Bid Number:	2015-011
Bid Title:	Joplin Public Park - 2015-011
Category:	Public Works
Status:	Closed
Additional Status Information:	Mandatory PreBid Meeting/Site Visit 8/11/15, 10:00 AM

SECTION 009113 – **ADDENDA #1**

A. Project Name: Joplin Public Park.

SECTION 009113 - **ADDENDA #3**

Sheet Title
ADDITIONAL NOTES AND LEGENDS

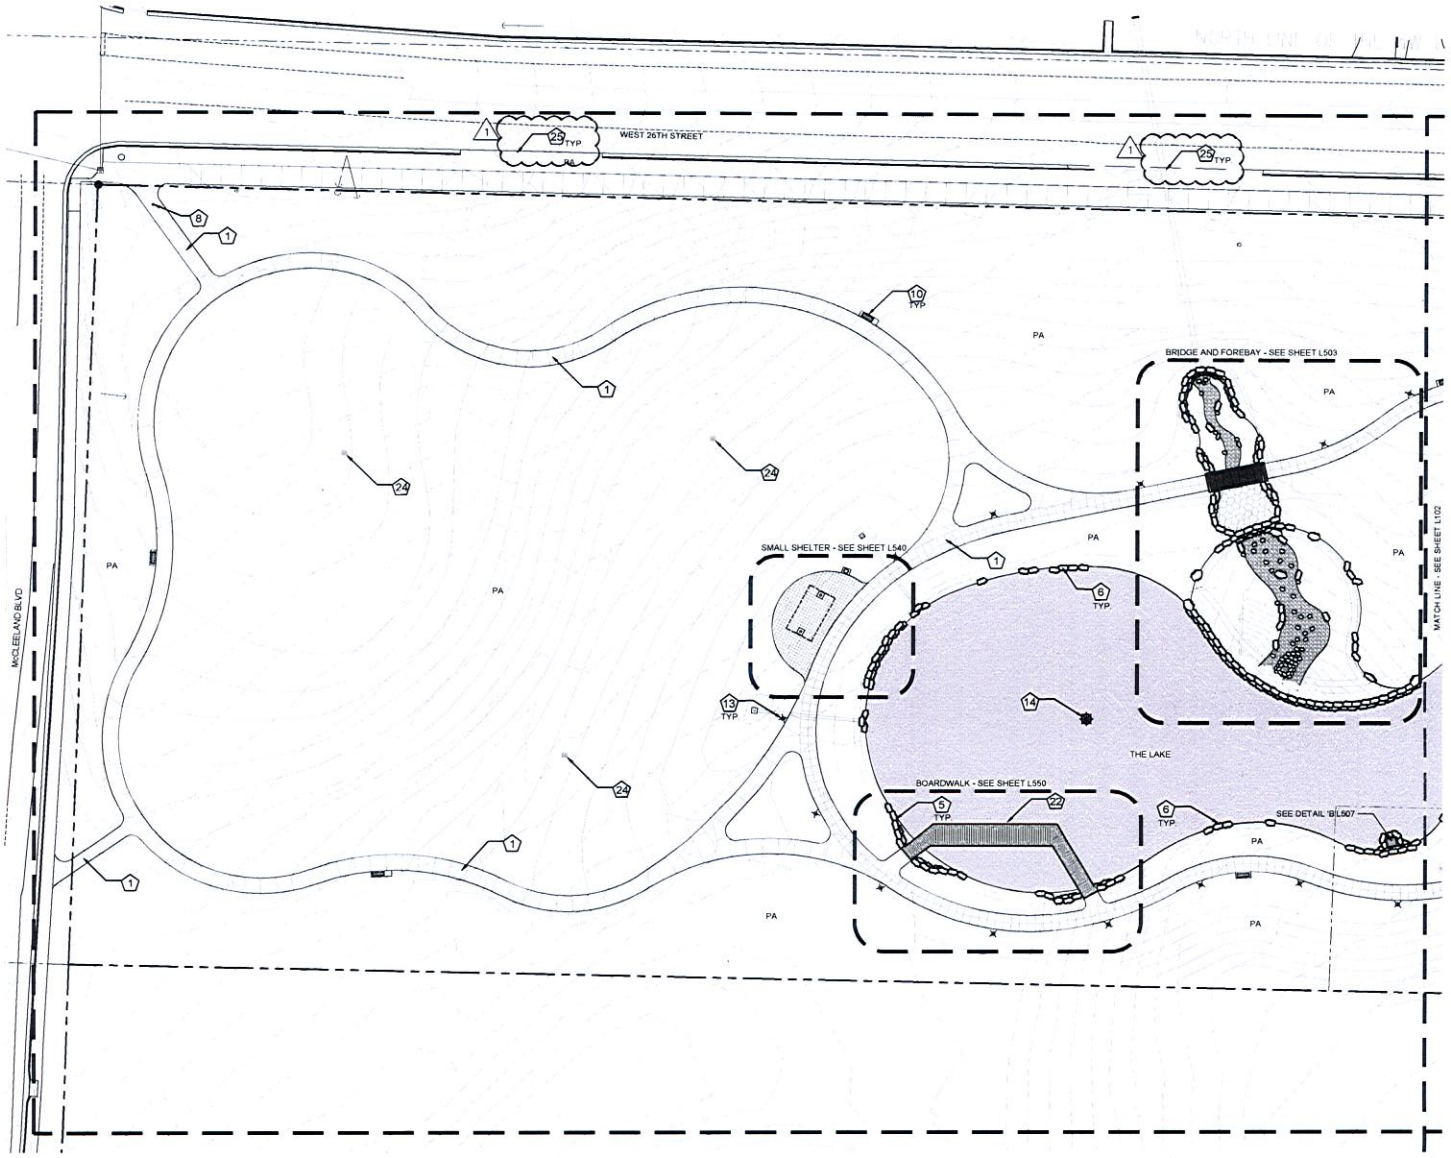
A. Sheet G002- Additional Notes and Legends.

Sheet Title
MATERIALS AND NOTES - AREA A

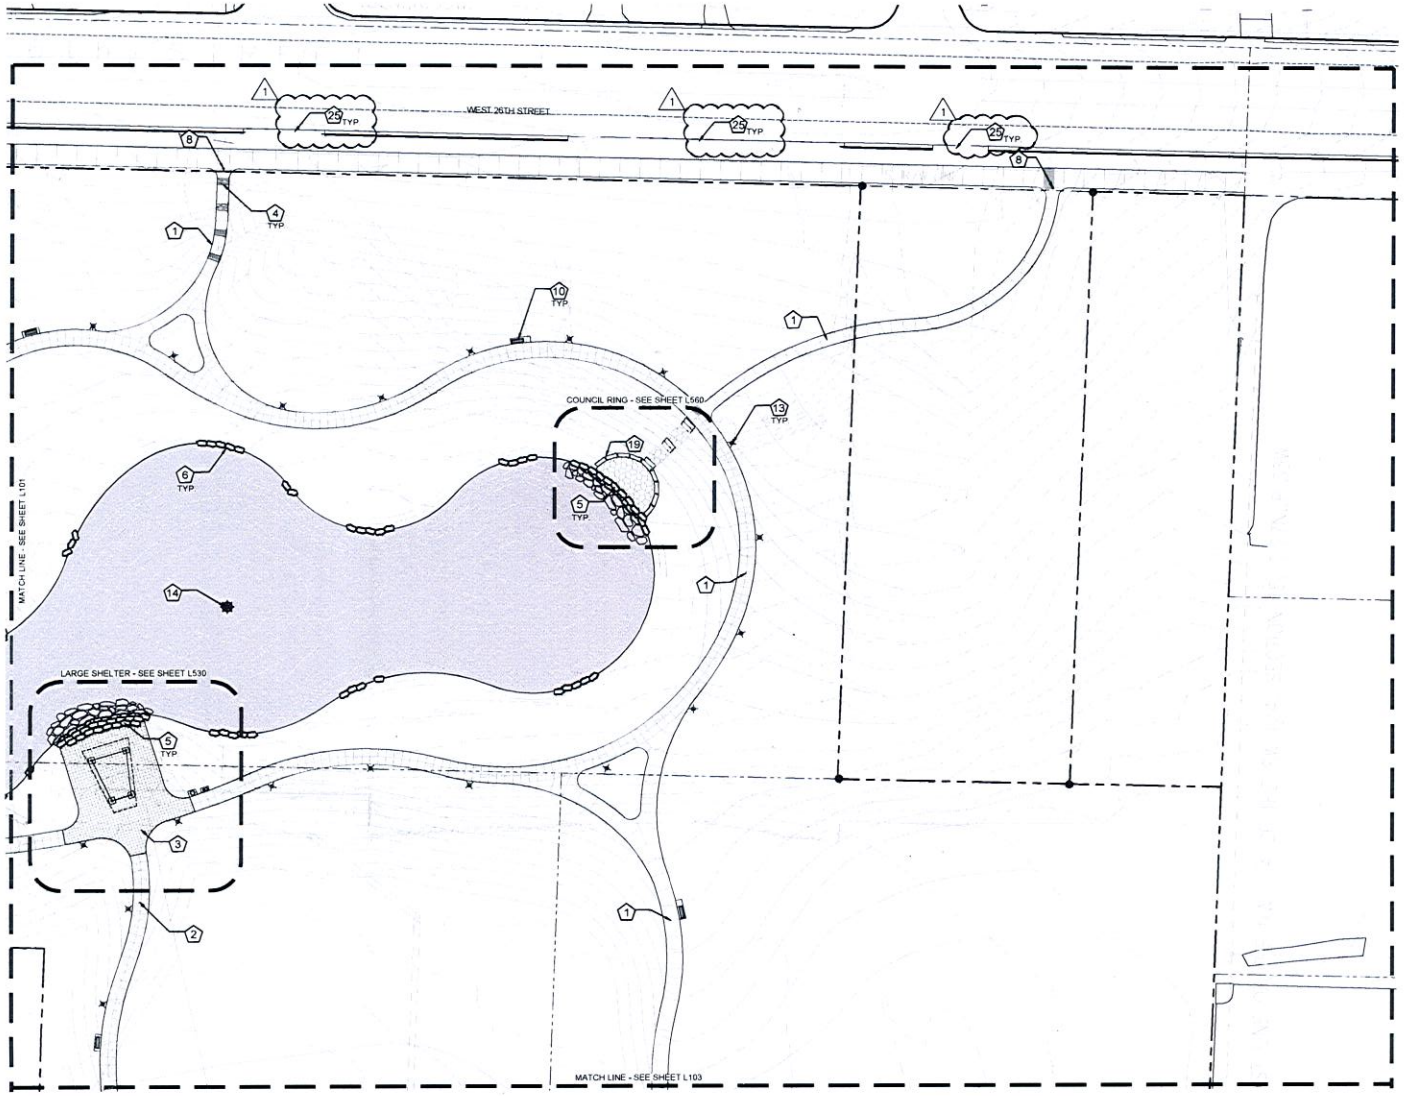
B. Sheet L101- Materials and Notes, Area A.

Sheet Title
MATERIALS AND NOTES - AREA B

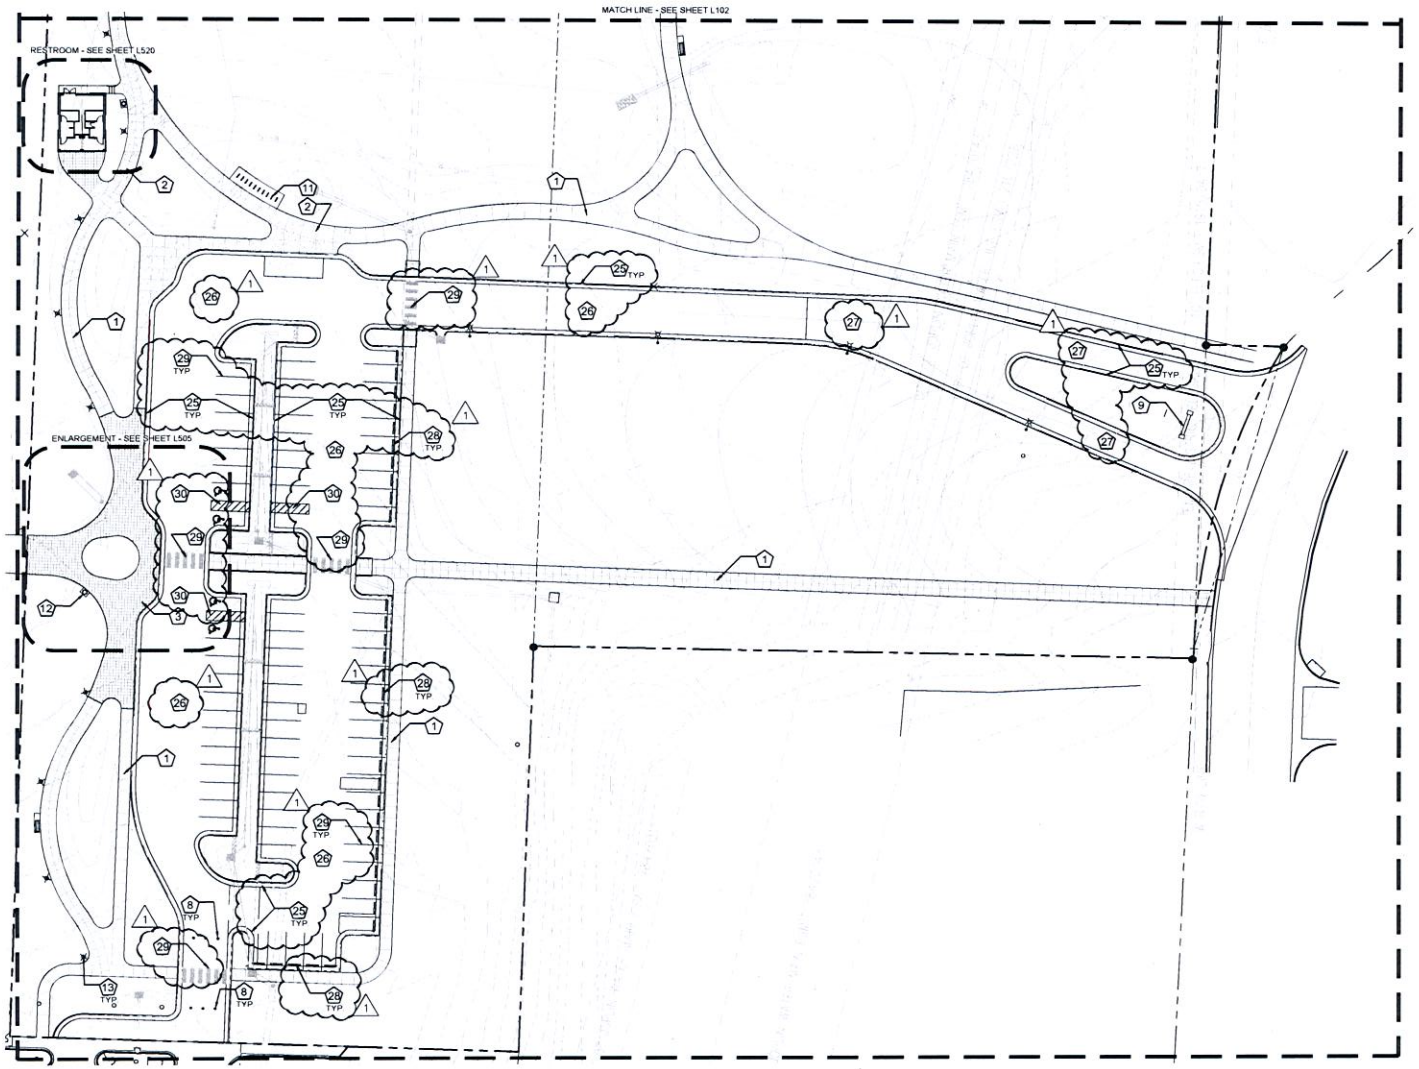
C. Sheet L102- Materials and Notes, Area B.

TYPE 'C' CURB INLET

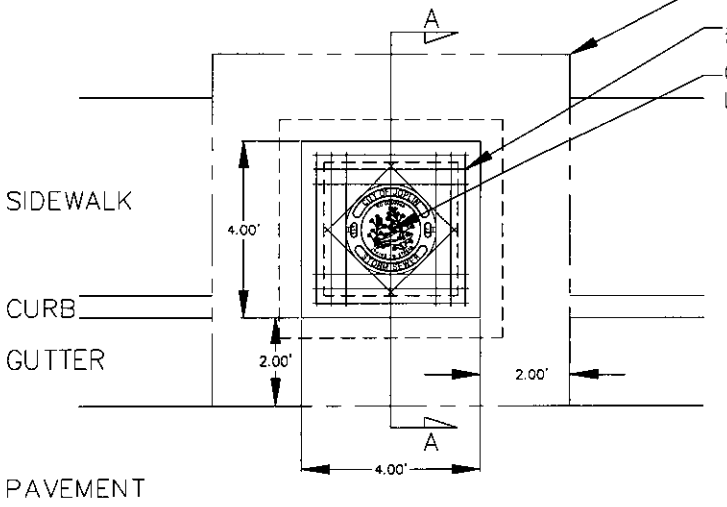
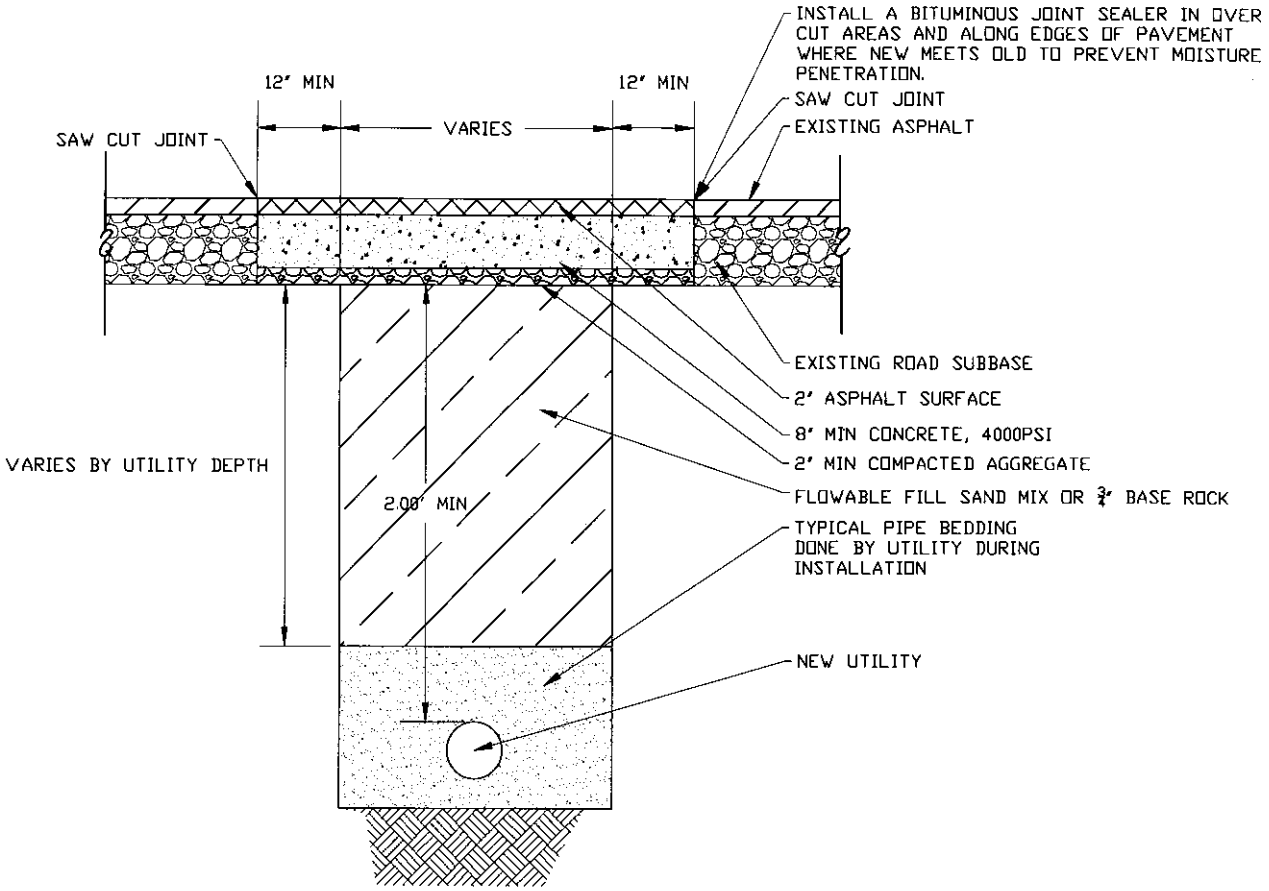
1. City Standard Detail, Type C Inlet, to supercede detail on sheet C500.
2. City Standard Detail, Pavement Repair, to supercede detail on sheet C500.
